**Fisher**

**Daniel Campbell** <dcampbell@leveldg.com>

Our client is looking forward to approval on the 6<sup>th</sup>. The attached plan is the detail of what Mike, Matt and I discussed in the field Monday. Mike and Matt had the opportunity to review and though there may be slight changes, agree in concept with the attached at the discretion of the board. I also attach the options for HDCP spaces as discussed during the public hearing – there are 8 total required for between 301 and 400 spaces. We can provide, any or all of the HDCP total spaces. I would amend the waiver on parking to add 2 to the waiver to allow us to move these around as necessary. Though they comply with the AAB it is certainly a concern of the Board that we provide more than required and at varied locations and adding two total spaces to our waiver request would give us the latitude. To note – it is just as likely we leave the spaces as we currently show them on the site plan.

Project Title:  
 5 FISHER STREET, FRANKLIN, MA 02038  
 FACTORY SQUARE FRANKLIN  
 K FISHER STREET LLC  
 1 FISHER STREET, FRANKLIN, MA 02038

**11-24 hdcp mod2.pdf**  
487K

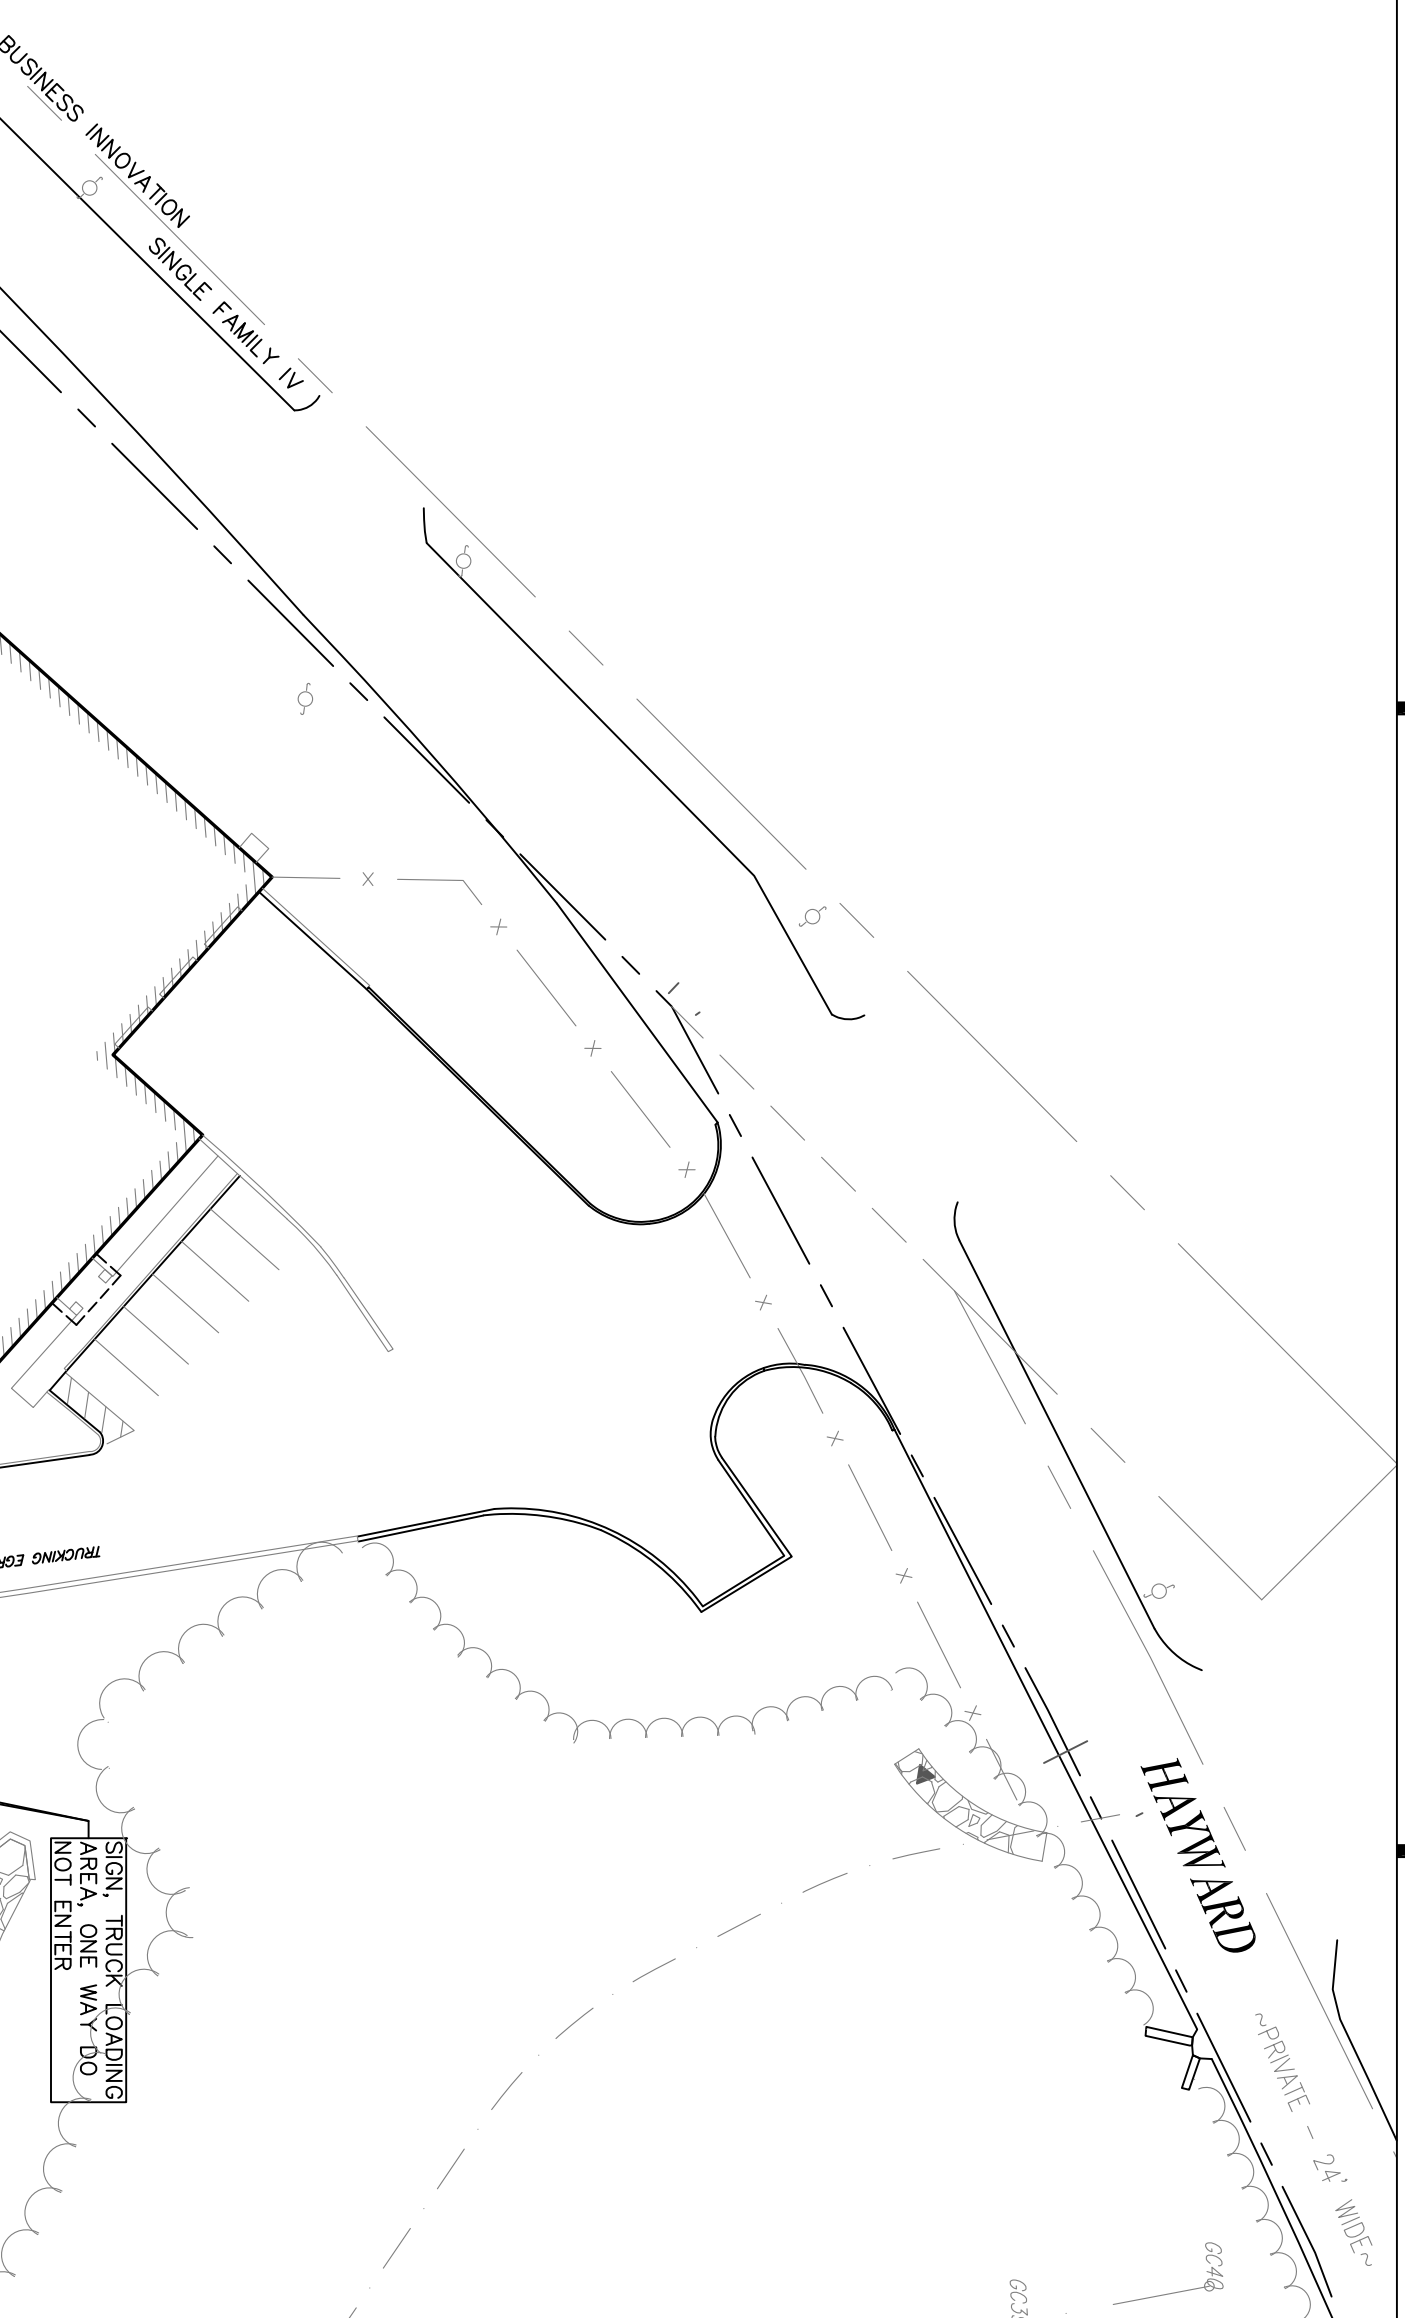
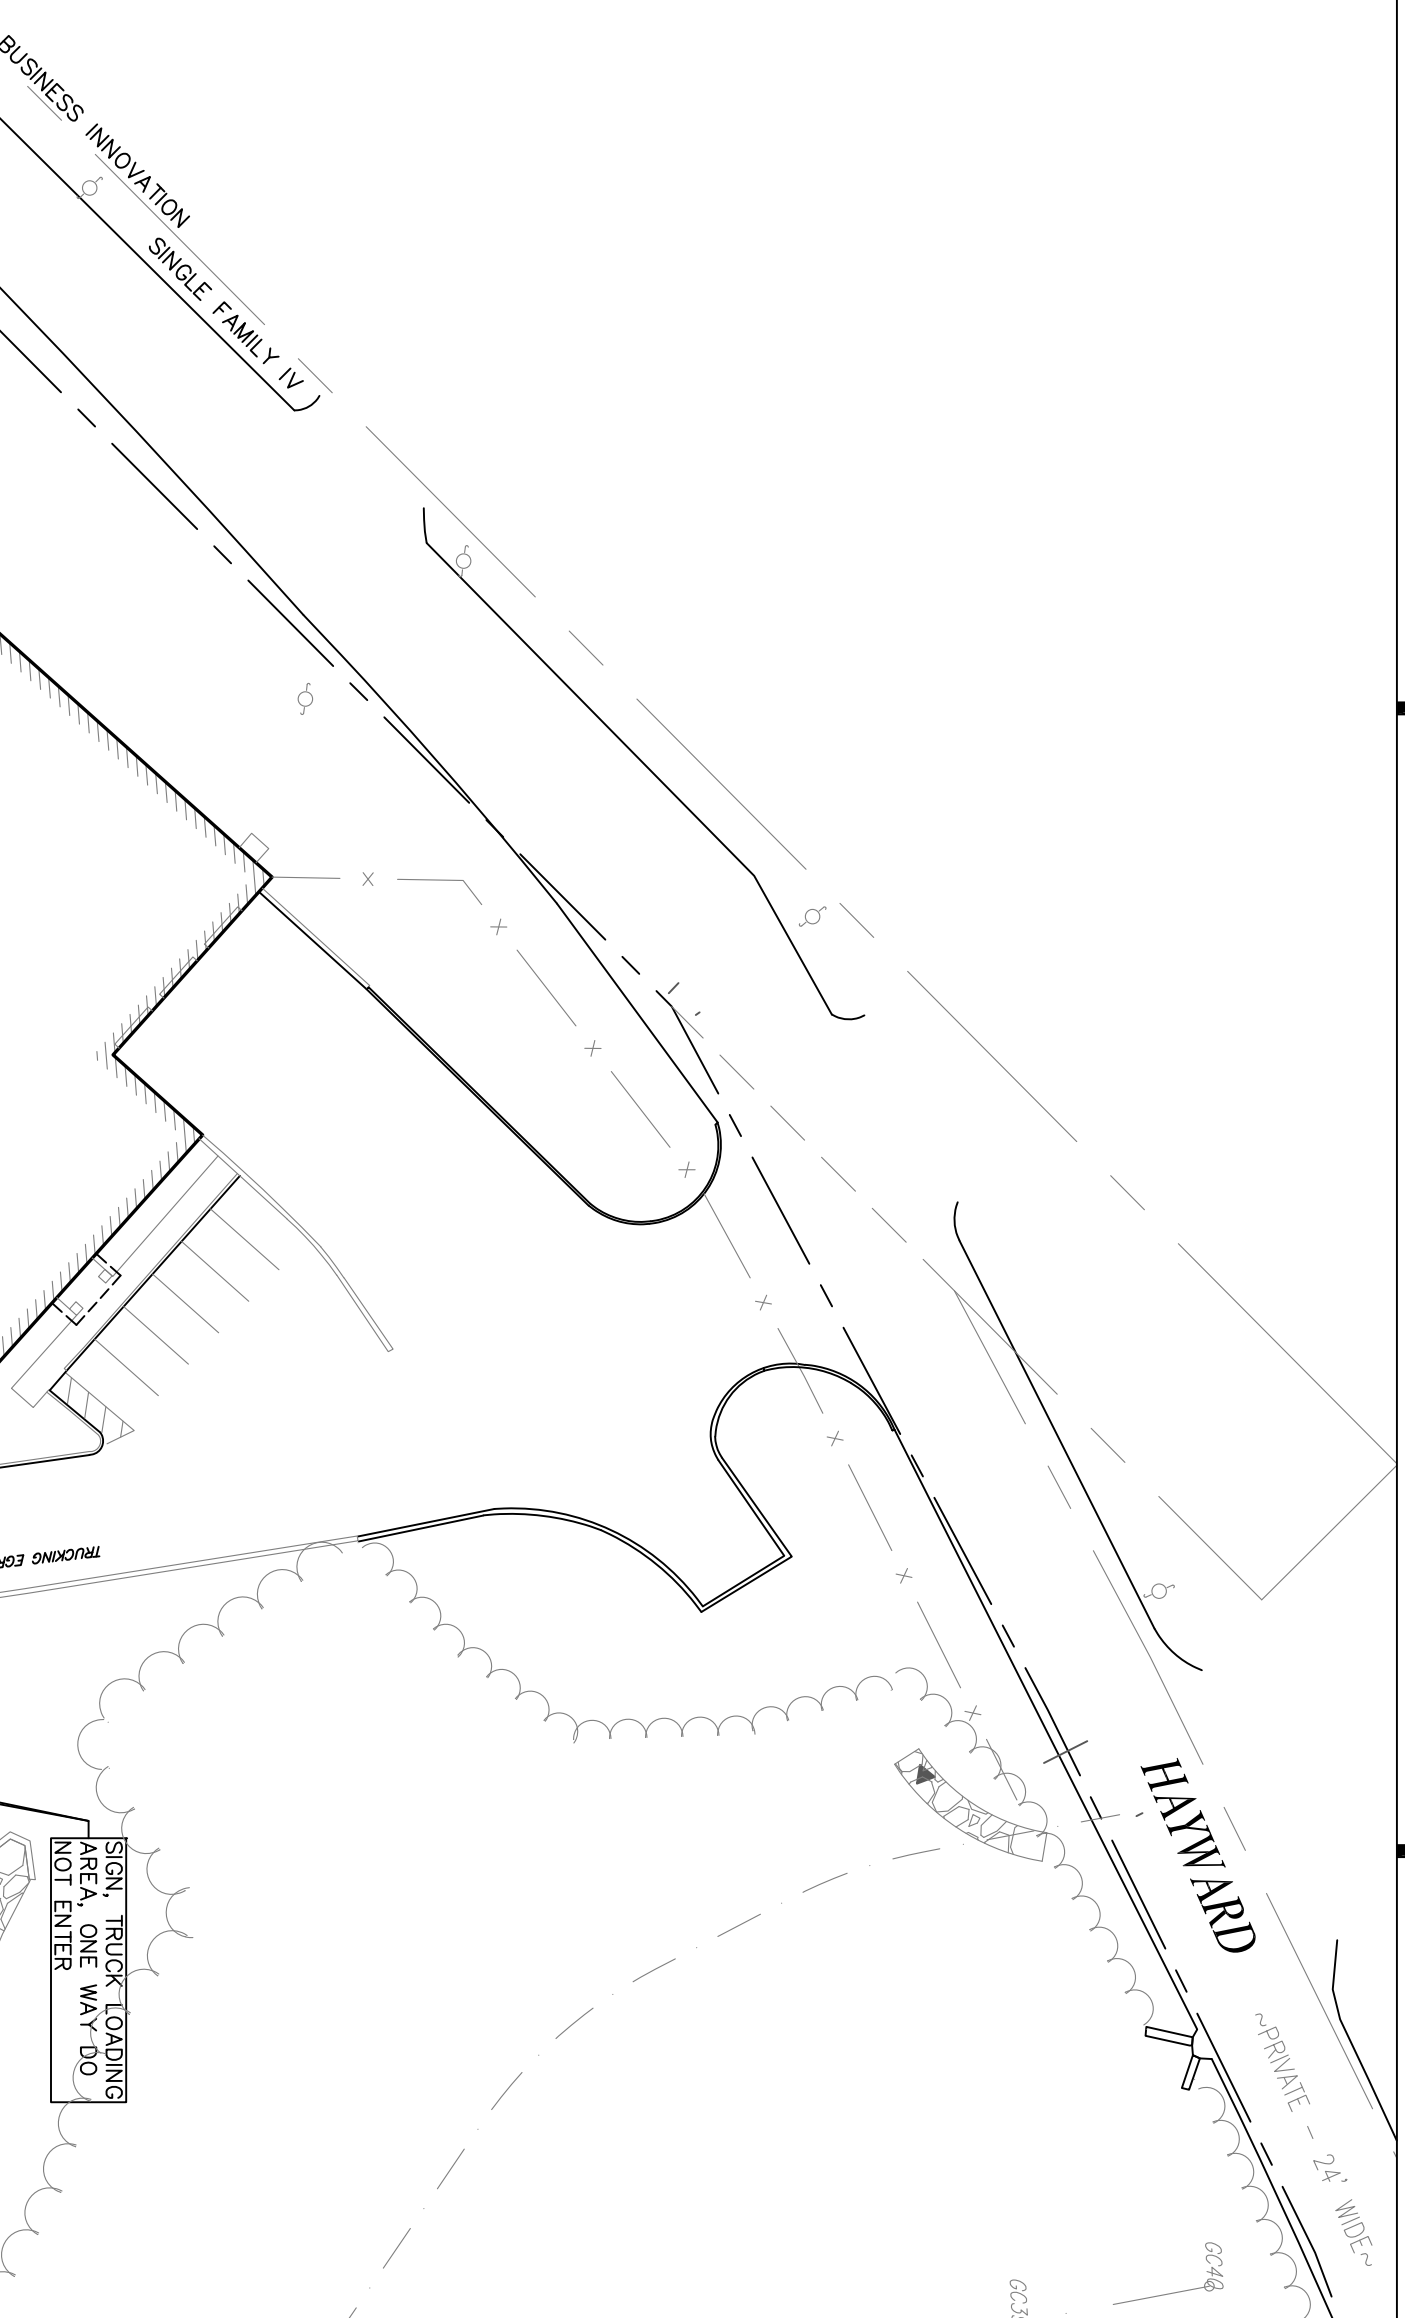
Additionally I know Mike has some anecdotal information on the sidewalk along Fisher which was brought up during the last hearing. The entire sidewalk meets HDCP code, there is however one pole which is just meeting minimum clearance. Though this area will be made better with the removal of the fence line and the planting of intentional shrubs and grasses instead of weeds the applicant agrees to the following:

Increase the passing pathway around utility poles to a min 42" width. This will be accomplished all the way around the pole and will allow for smooth transition and not require abrupt turning.

Replace any panels which utilities disturb

Replace any panels which are heaving or in disrepair along Fisher (I don't believe there are any)

All of these would be in conjunction with the DPW at the time of construction.
